WB ASM Workstation

Current vs Modification

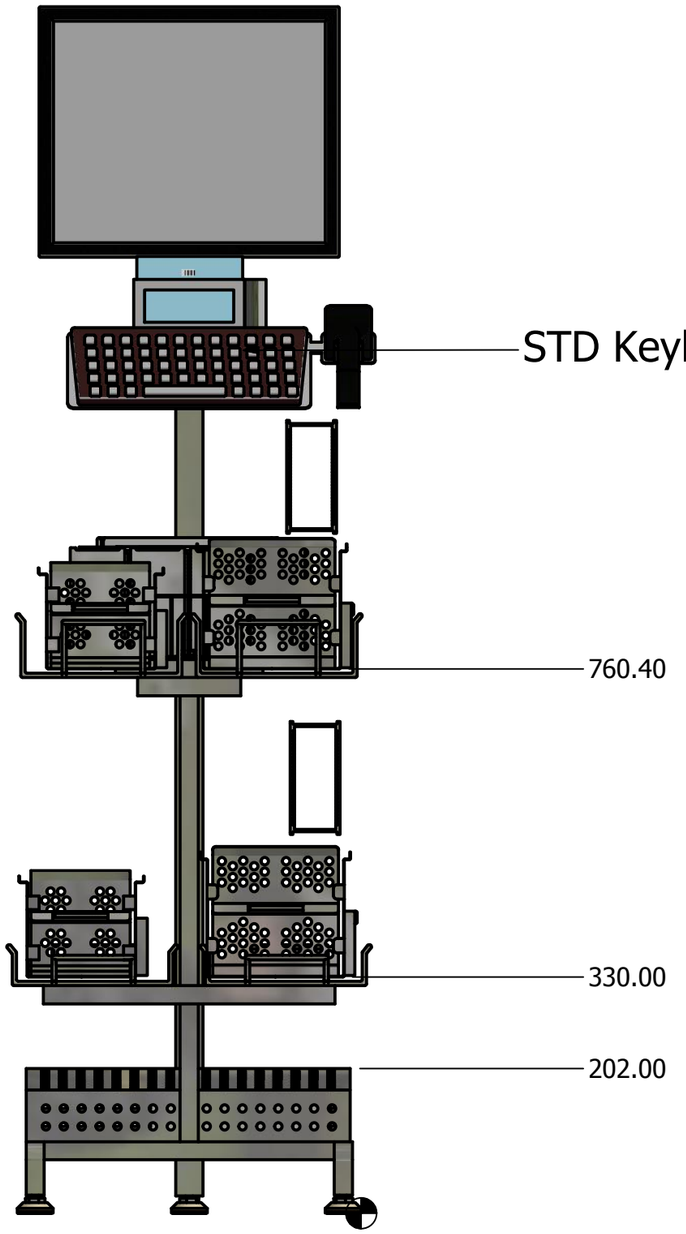
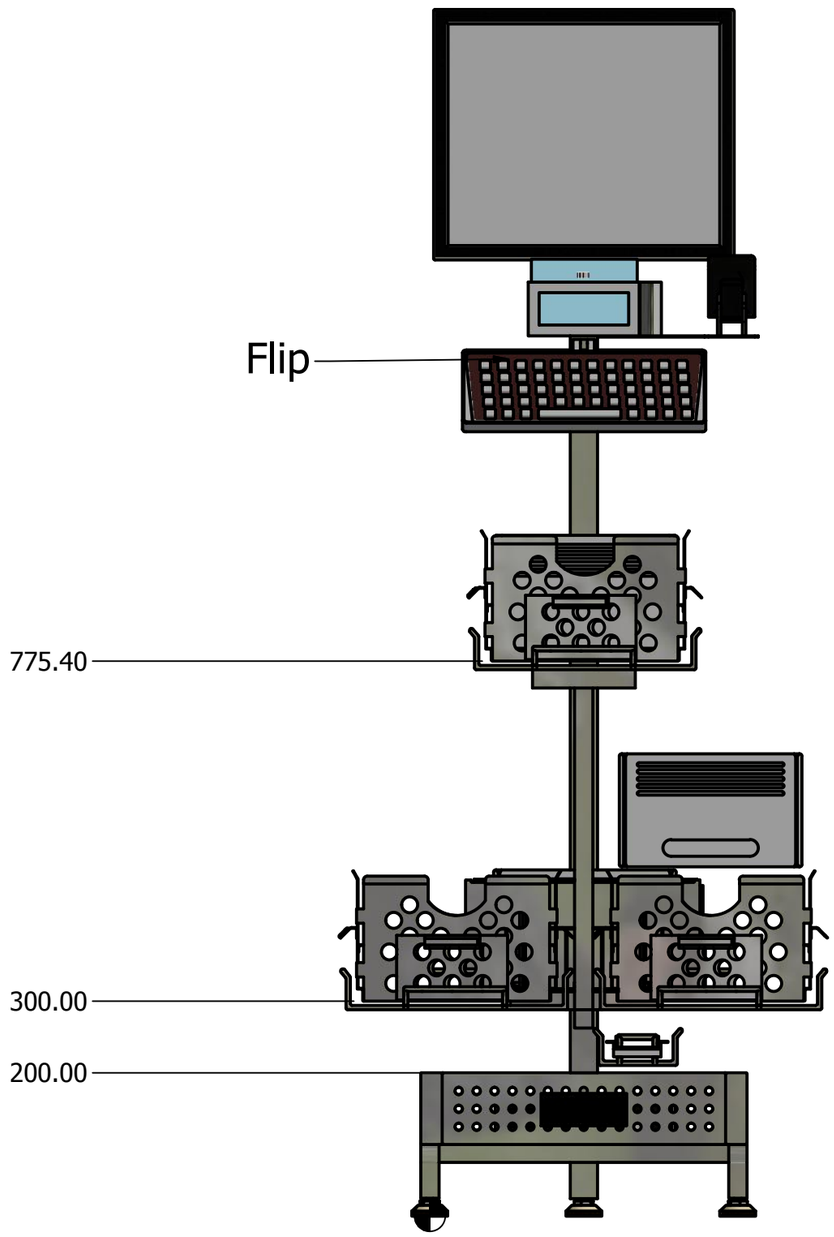
1. Change keyboard holder from fix to flip
2. Change the height wiring holder
   330 to 250
   760 to 725

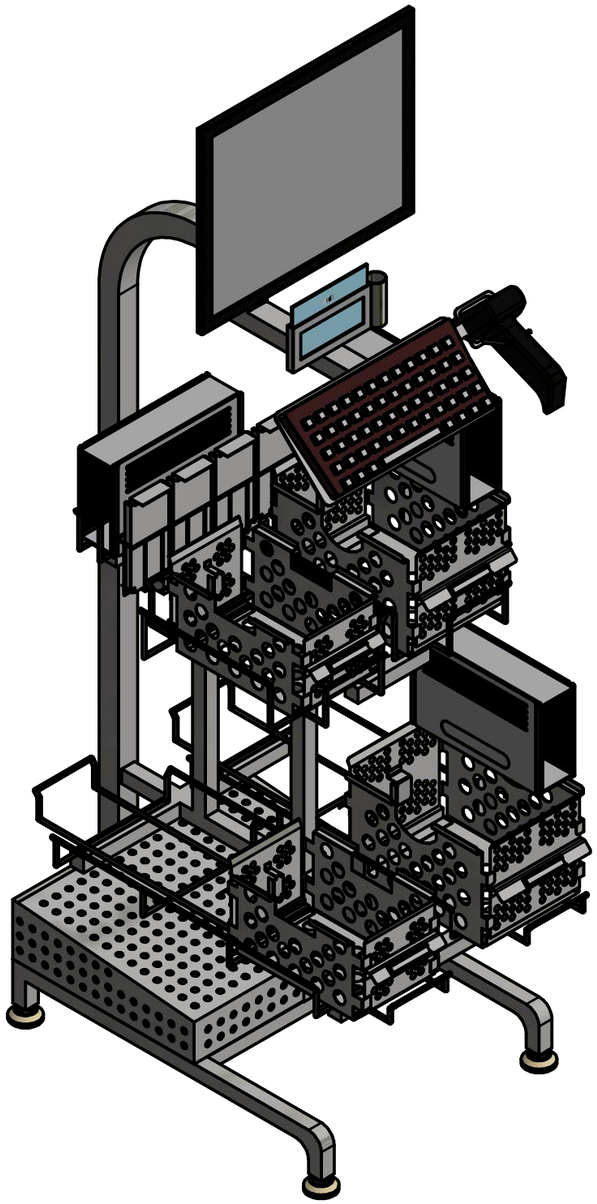
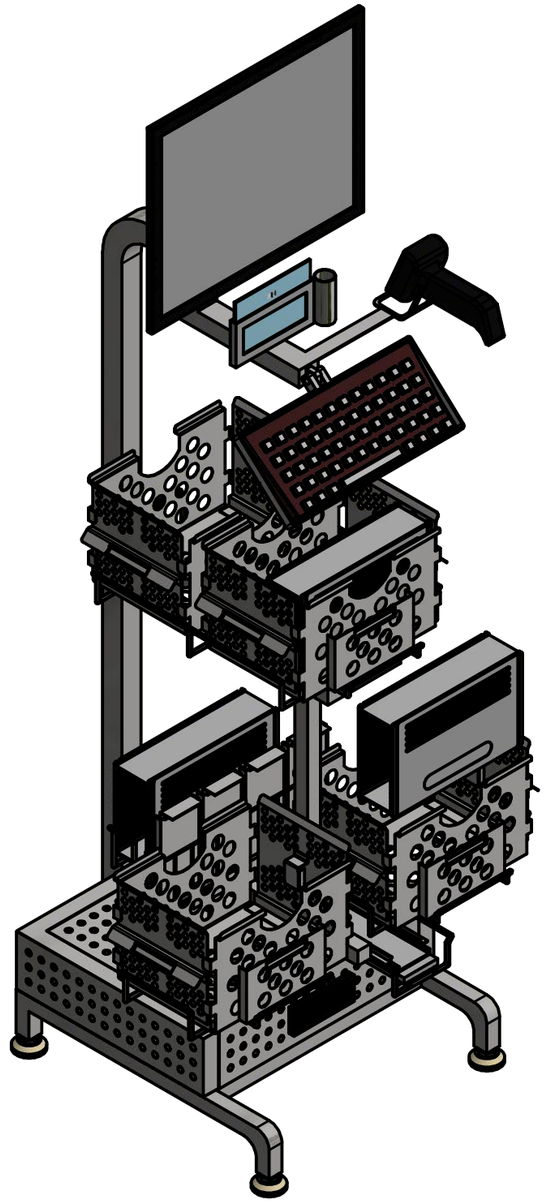
1. Change the wiring holder from Portrait to landscape
2. Change WIP holder from 6 to 4 caontainer
3. Change CPU Holder
4. Change WIP Holder
